SFD/ INSTALL (48) GROUND MOUNT SOLAR PANELS

HYBRID SOLAR POWER SYSTEM
ERIC DEMENTHON
6582 GUILFORD RD
CLARKSVILLE, MD 21029

From: Freemon, Robert
Sent: Thursday, February 15, 2024 9:58 AM
To: Eric DeMenthon
Cc: eric@dementhon.com
Subject: RE: 6582 Guilford Rd.

I have reviewed building permit B23004633 and here are my comments. The proposed ground mounted solar panels appear to be close to (if not in) the designated reserve sewage disposal area on the property. Health needs to see a revised site plan showing the reserve sewage disposal area and its distance to the proposed solar panel location. The solar panels must be 5ft from the sewage disposal area and cannot have electrical lines crossing it. If it does enter the SDA the solar panel location will need to be revised or a new sewage disposal area will need to be tested for. Attached are our records regarding the properties well and septic system. If you have any questions let me know.

PV-1

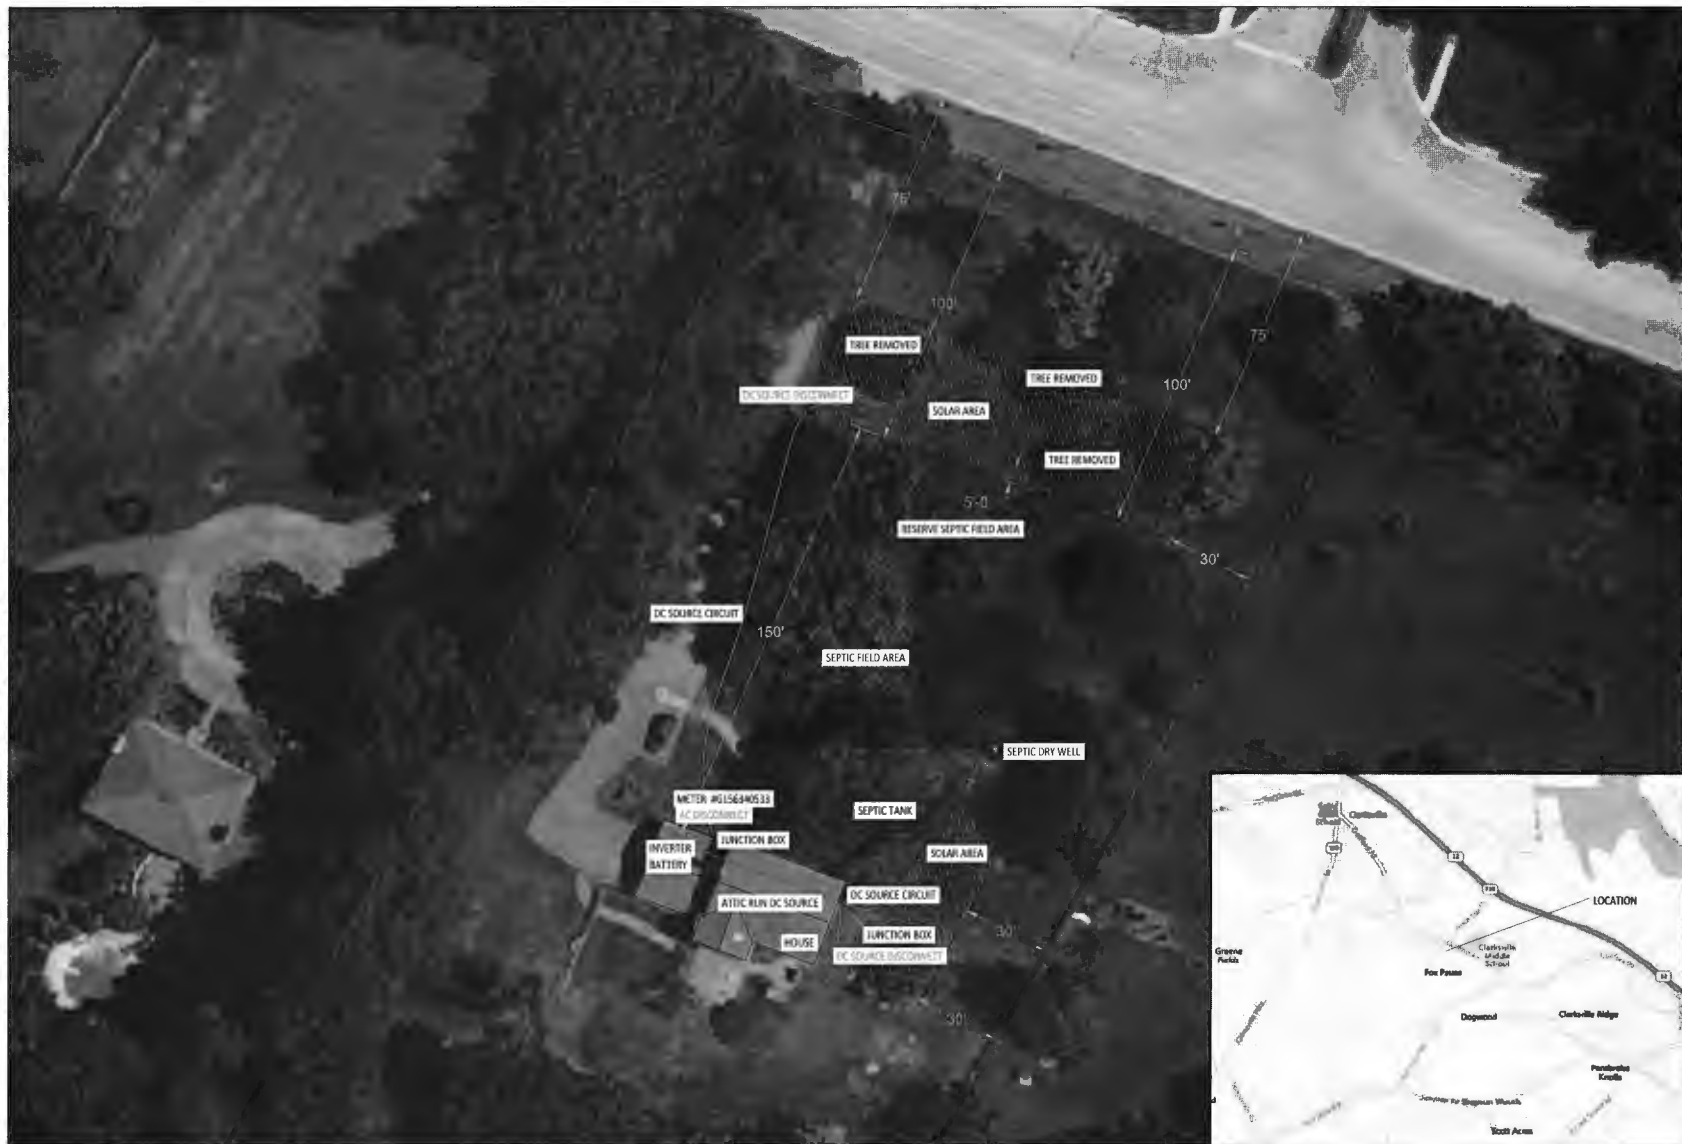
Eric,
Health has approved building permit B23004633 with the revised plan showing the primary and secondary fields. If you do decide to utilize the secondary area and need to cross the septic line Health will need the letter and a revised site plan submitted to DILP. The latest site plan shows the wiring going through the house and not crossing the septic line. If you have any further questions let me know.

Hi Eric,
The site plan you uploaded looks approvable. It looks like you already did submit it through the building department since I can see it on their permit site. We prefer not to have the electric lines cross the septic lines (line between tank & house and/or line between tank & drainfield). However we have approved them in the past. I see what your saying about minimizing the shutoff points. If you wish to have it cross you can do that. We would need something in writing from you all stating how you will install it (suggestions you can use are below). This letter/instruction manual can also be uploaded to the permitting site so all departments can see it. If you do submit a revised site plan shoot me an email since I do not get notification of revisions on their site. The only caution I have about it is the home owner will need to have that location marked as to not forget about it. The concern would be if a septic repair needed to be done and no one tells the septic contractor there is an electrical line crossing the septic line. If you have any further questions let me know.

- Trench for electric line will be hand dug over portion of septic line shown on plan.
- Electrical line will be installed 18" above septic line.
- Electrical line will be installed with sleeve for protection.
- Have letter/instruction manual written on letter head.
